Consumer Product SAFETY ALERT

November 1988

Hedstrom to Offer Glide Guard Kit for Gym Sets

UNPROTECTED BRACKET

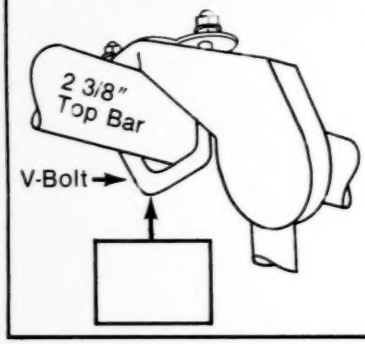
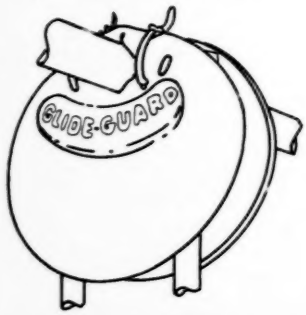
Between 1982 and July 31, 1988, Hedstrom sold approximately 370,000 gyms with glide ride assemblies which have 2-3/8 inch top bars. Hedstrom is aware of 12 incidents where the user has stood on the slide or crossbar, reached over to propel or stop the motion of the ride and has entrapped or pinched a portion of a finger in the bracket mechanism, resulting in severed fingertips or severe lacerations.

The affected units have a model identification label located on the top bar. These model numbers are: Hedstrom Brand, model numbers 4-277, 4-377, 4-677, 4-777, 4-778, 4-877; Sears Brand, model numbers 72226, 72026 and 72066. These models incorporate a glide ride assembly with a 2-3/8 inch top bar using a V-bolt bracket attachment.

Hedstrom Corporation will provide a free Glide Guard Kit and assembly instructions to all owners of the affected models.

GUARD INSTALLED
